SUBJECT: 1055 (G-10) CHOKE CABLE

SERVICE BULLETIN

237

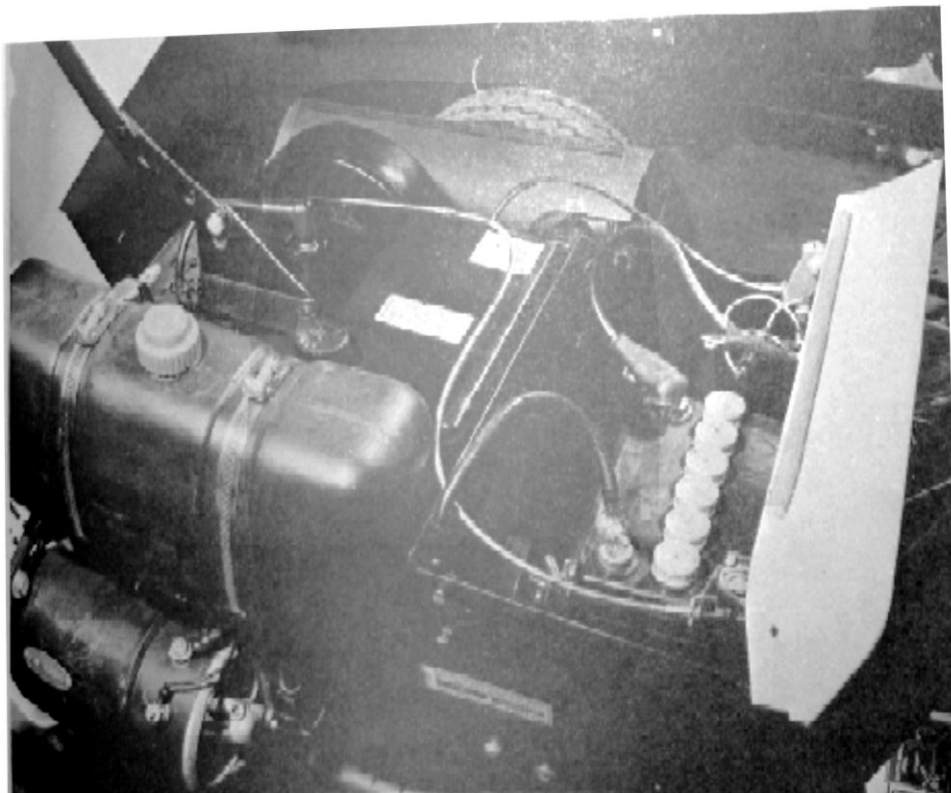
On some units, the choke cable may have been installed incorrectly on the above model tractor. This cable may have been routed underneath the heat shield. Heat from the engine exhaust pipe then may cause the choke cable to become hard to operate or function properly.

If you receive complaints, or have units in stock, check the routing of the cable and reinstall as shown in the photo. Check operation of choke plate so that a full open and closed position is obtained.
